SUBDIVISION COMMITTEE
METROPOLITAN AREA PLANNING COMMISSION

STAFF REPORT
(Revised Preliminary Plat)

CASE NUMBER: S/D 89-37 - PARK WEST PLAZA ADDITION

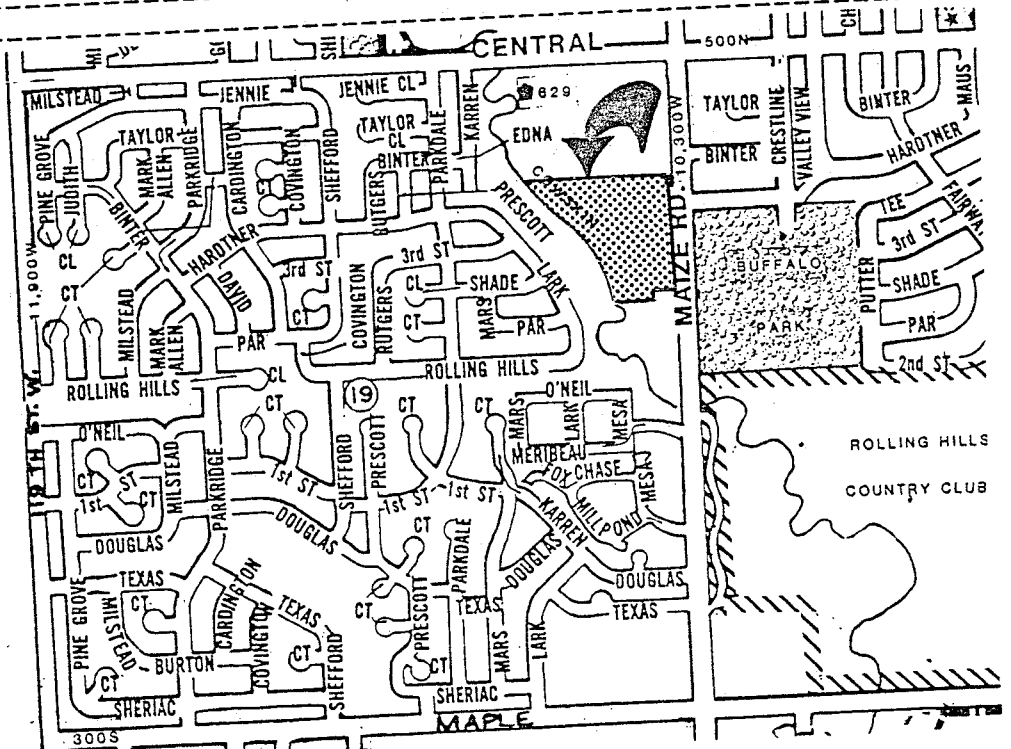
NOTE: This plat was deferred, at the applicant's request, from the June 15, 1989 Subdivision Committee meeting. A zone change (Z-2931) has been approved for this site subject to platting by January 10, 1990. The applicant also intends to submit zone change requests for the shaded areas on the revised preliminary plat, so as to avoid split zoning. Lots 1, 2, 3, 5 and 6 are intended to have "OC" zoning, Lot 7, "BB" zoning and Lot 4, "R-6" zoning.

- A. In order to assure compatibility between the lots being platted and the intended uses for those lots, the applicant shall request a zone change to "OC" for those portions of Lots 1 and 3, and to "BB" for the portion of Lot 7, that would be zoned "R-6" under the existing zone change case (Z-2931). The applicant shall provide a revised legal for what will correspond to the original zone change area in case Z-2931, but minus or adjusted for the portions of the site involved in this second zone change.

- J. Provisions shall be made for ownership and maintenance of the proposed reserves. The applicant shall either form a lot owners' association prior to recording the plat or shall submit a covenant stating when the association will be formed, when the reserves will be deeded to the association and who is to own and maintain the reserves prior to the association taking over those responsibilities.

- L. The final plat shall state in the plattor's text the purposes of the proposed reserves as well as who is to own and maintain the reserves.
- M. On the final plat, Lot 4 shall indicate a 50-foot building setback and Lot 7 shall indicate a 20-foot building setback from the cul-de-sac.

- N. On the final plat, the street serving this plat shall be named Maize Court.
- O. Prior to, or at the time of submitting the final plat, the applicant shall submit a drainage plan to City Engineering for review and approval.
